**From:** ERICK REDDEKOPP  
**To:** [BPS Comprehensive Plan Testimony](#)  
**Subject:** Proposed Bike Path on Hayden Island  
**Date:** Thursday, November 17, 2016 3:25:14 PM

## Portland City Council Public Testimony Against “2035 Comprehensive Plan Early Implementation Council Amendments”, Amendment 38, which reads:

**Re: Testimony Regarding Comprehensive Plan Early Implementation Amendments on Behalf of Multiple Property Owners, Including Killian Pacific, Oregon Racing, Broadmoor Inc., SolTerra, and WREH Lloyd Plaza**

## 7. Killian Pacific - Lovejoy Medical (2525 NW Lovejoy)

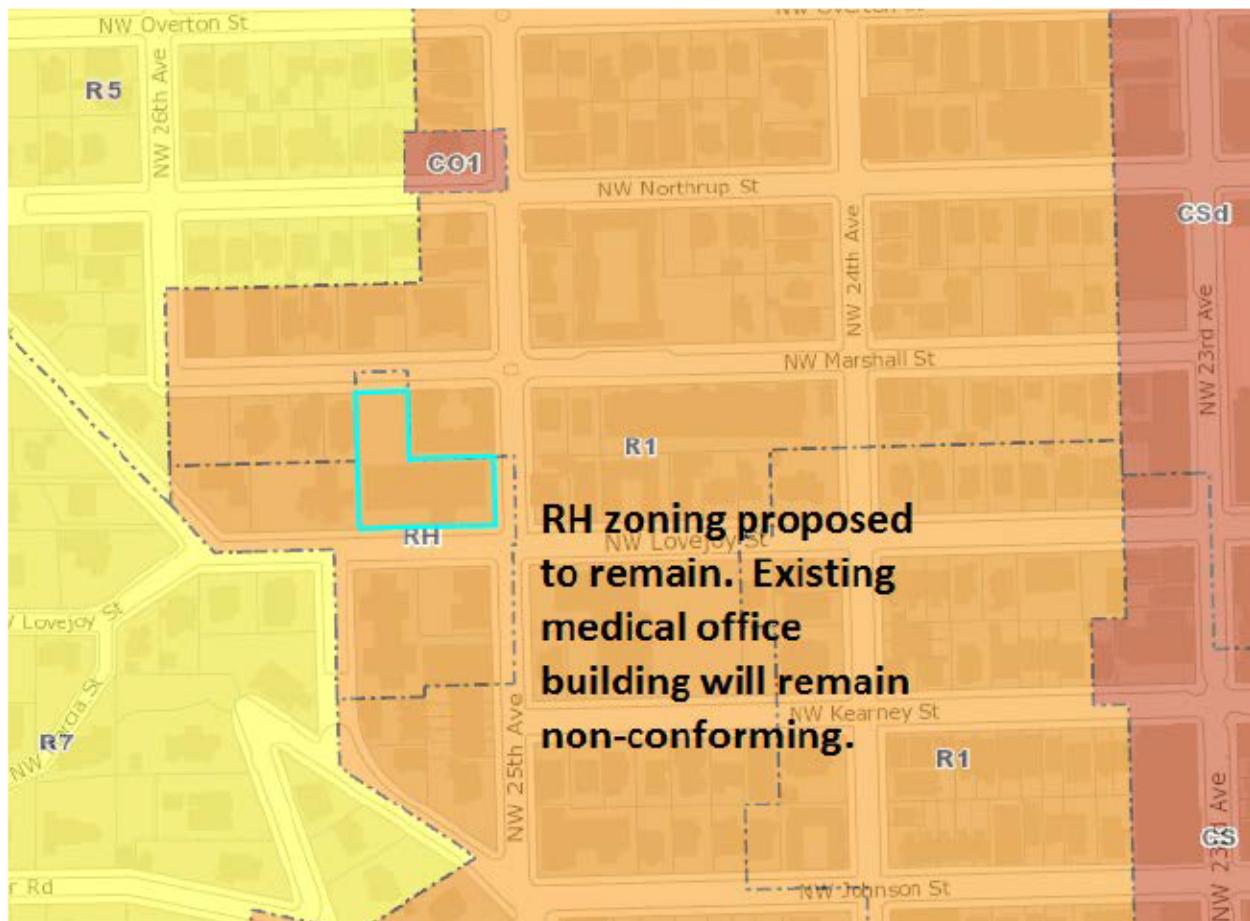
**Request: Add Property to Item 53 List for Future Rezoning and Comprehensive Plan Consideration by Planning Staff (will allow current use to become conforming)**

#### **8. Killian Pacific - Pottery Barn (310 NW 23rd Avenue)**

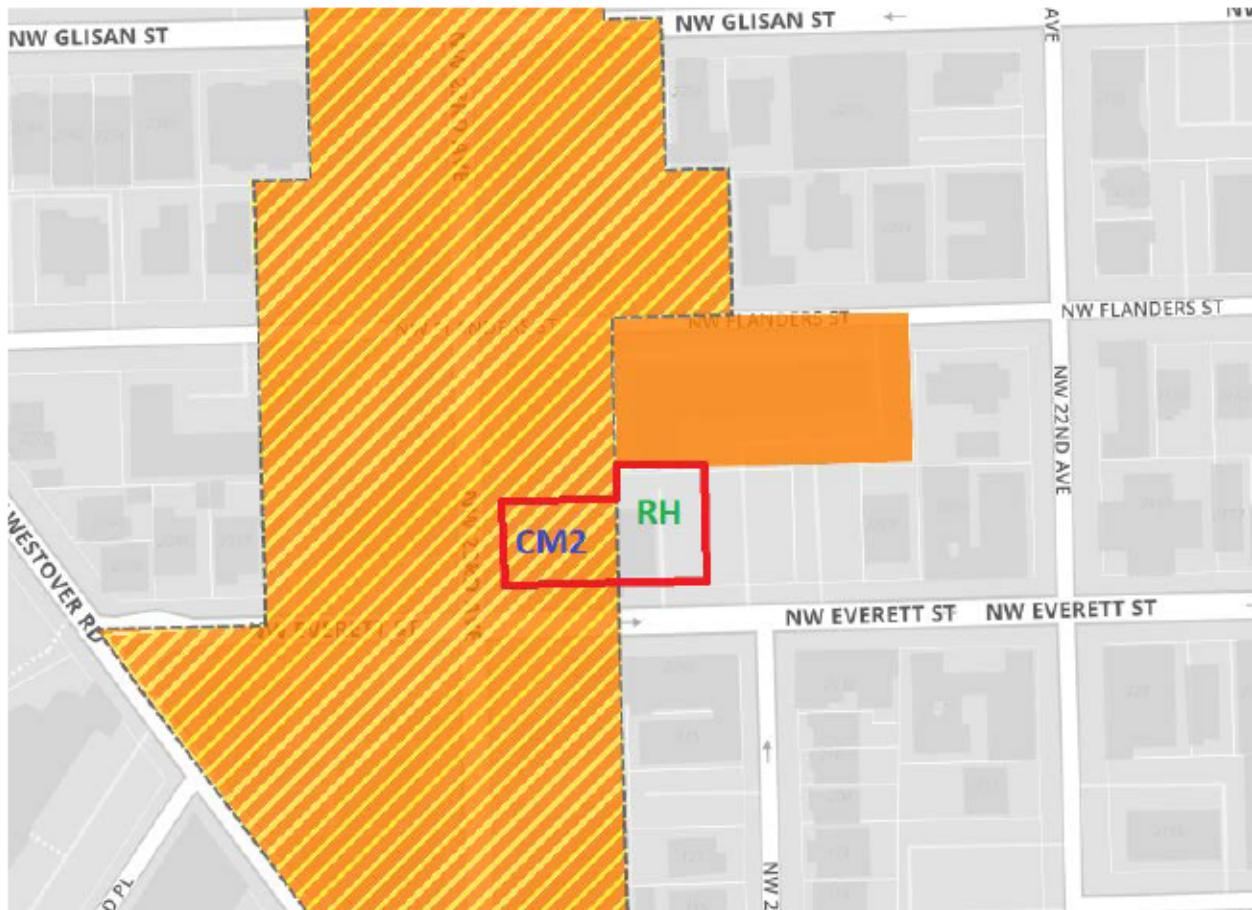
**Request:** Support Proposed Amendment 53 which contains this item (will allow current use to become conforming)

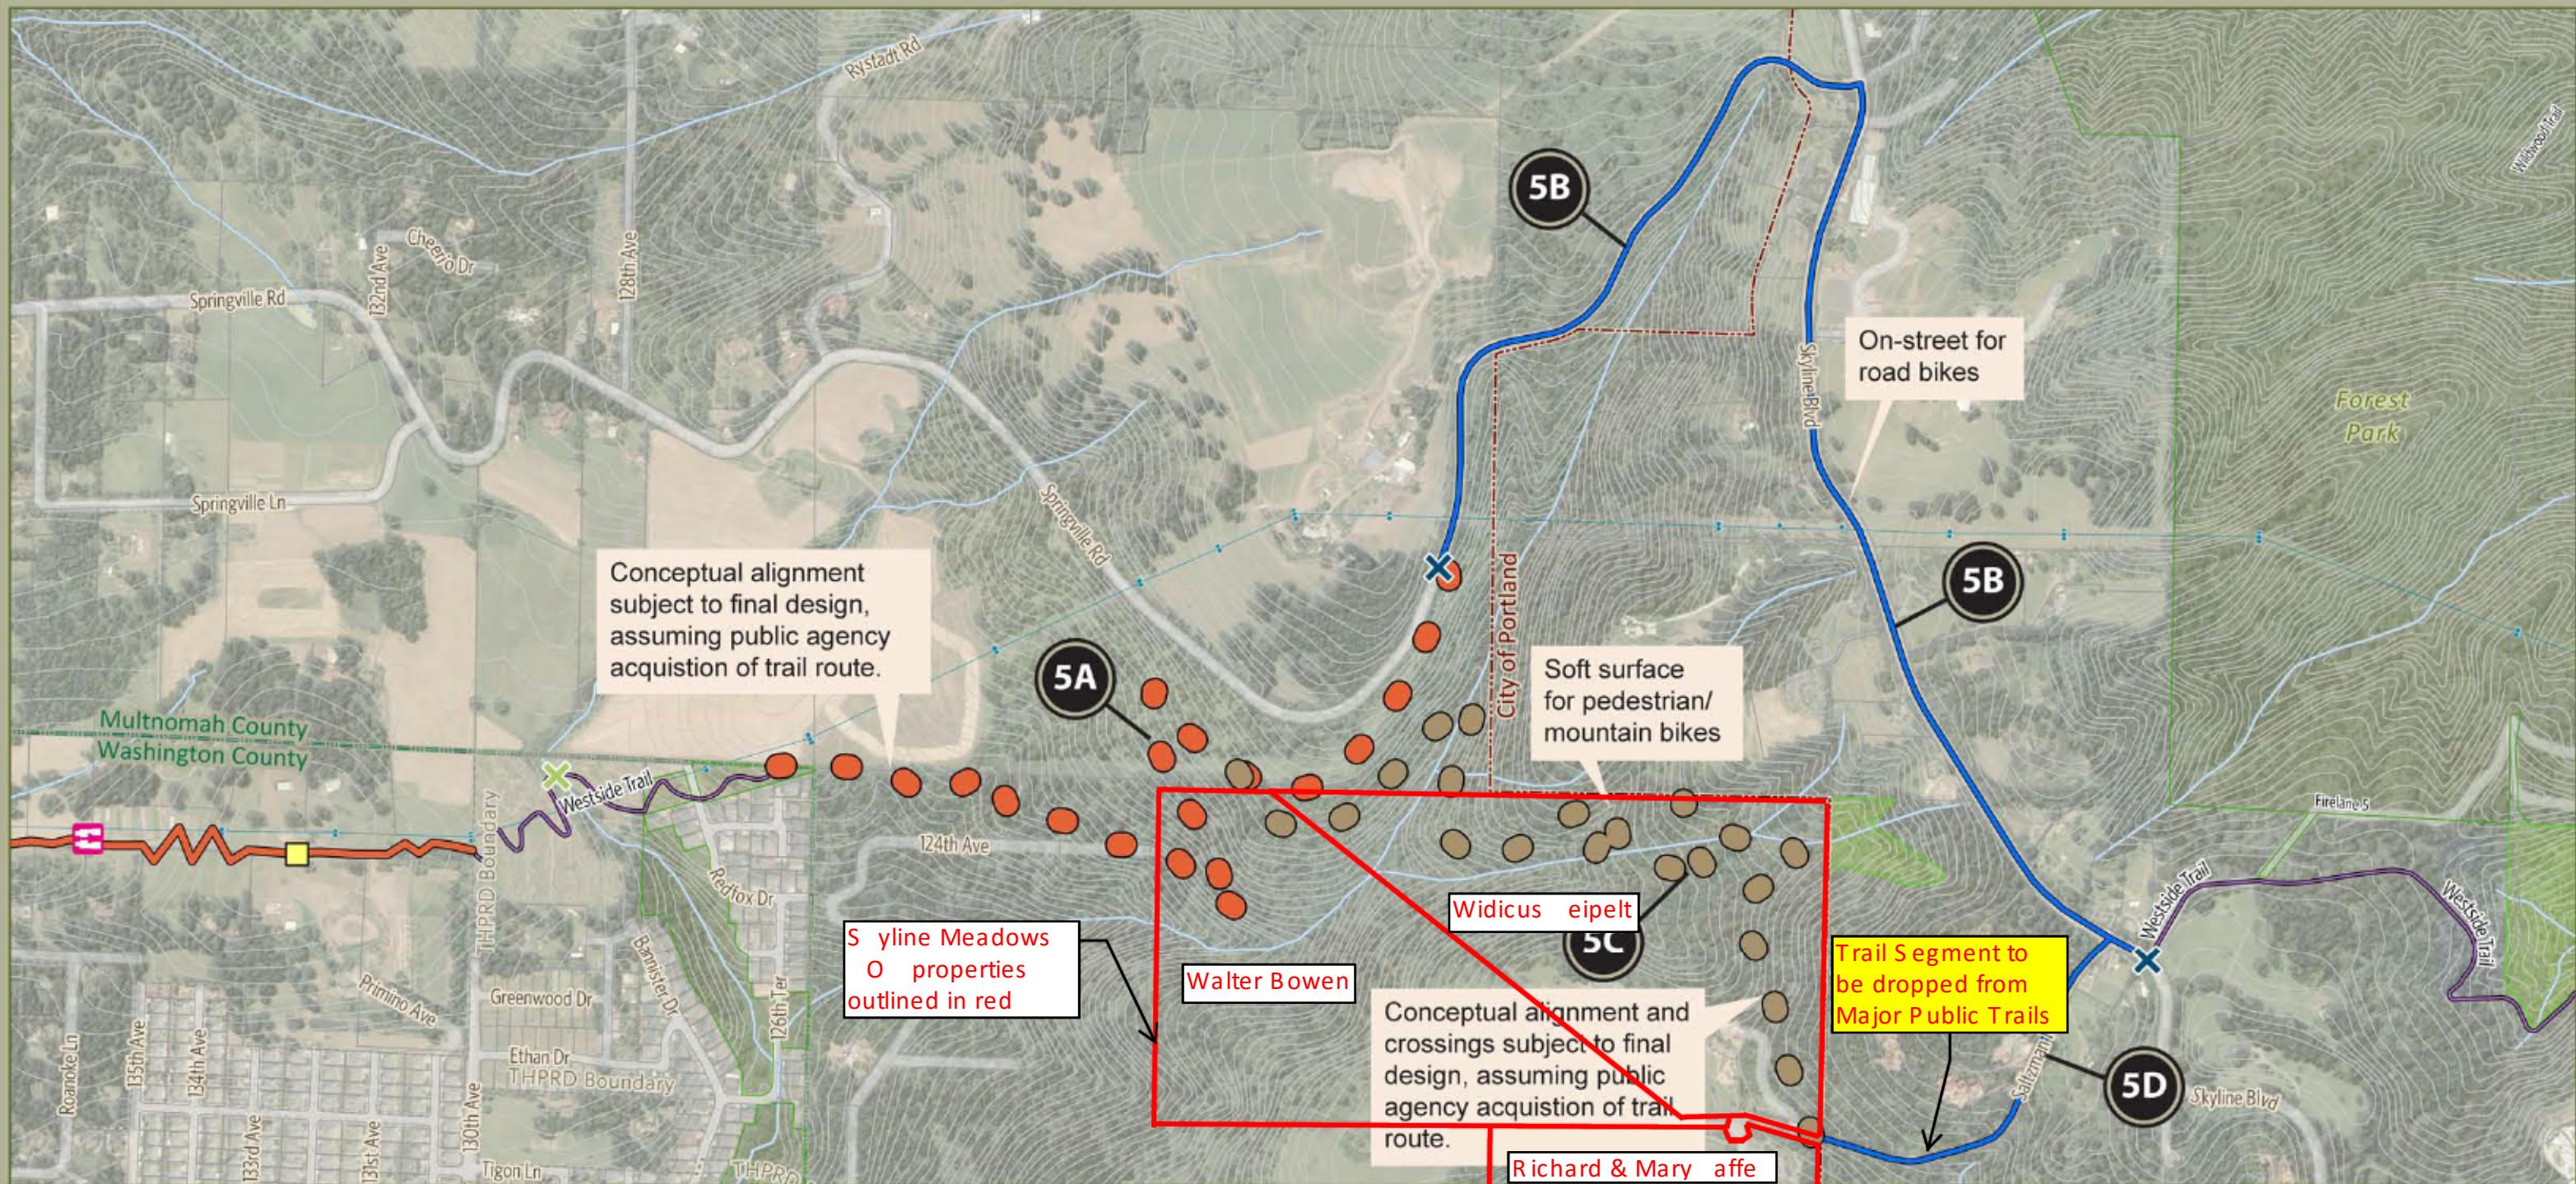
**We met as a group yesterday and discussed your recent letter. From the information we have it appears that the proposed Westside Trail might cross our property.**

**Please be advised that we will not provide an easement which would allow a trail alignment through any portion of our Saltzman Road property.**
